This is a project log entry for [FPGA Computer/Eval board](#)

Defect list

Foorprint:

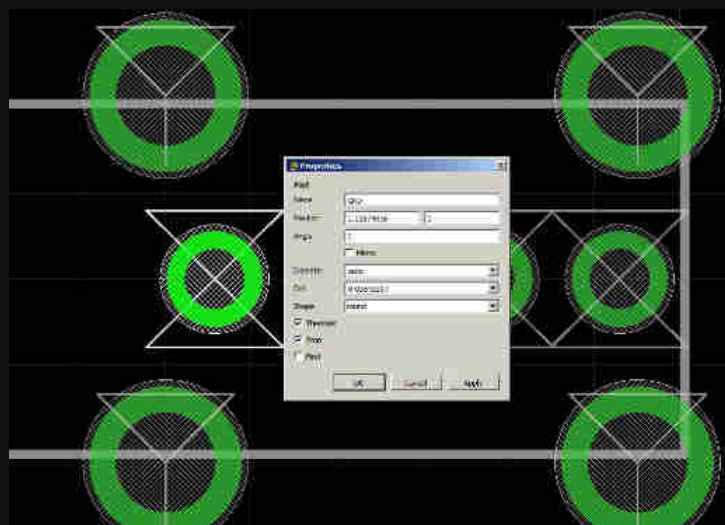
Library: con-usb-2.lbr by Erik Christiansson; also con-usb-3.lbr by same author

Level: Serious, require localized copper change

Problem has not been resolved in con-usb-3.lbr at Cadsoft ftp.

Acon UAR80-4* datasheet clearly shown pin 1 location (USB Bus Power), but instead it is connected to ground. Seems like all the pin numbering is wrong, so all pins are affected.

From a mechanical strength/appearance point of view, I should keep the connector as is, USB signals are best reversed at RN19 to preserve the routing. Power/ground can be reverse by cutting trace and thermals next to connector pin and jumper by magnetic wire.
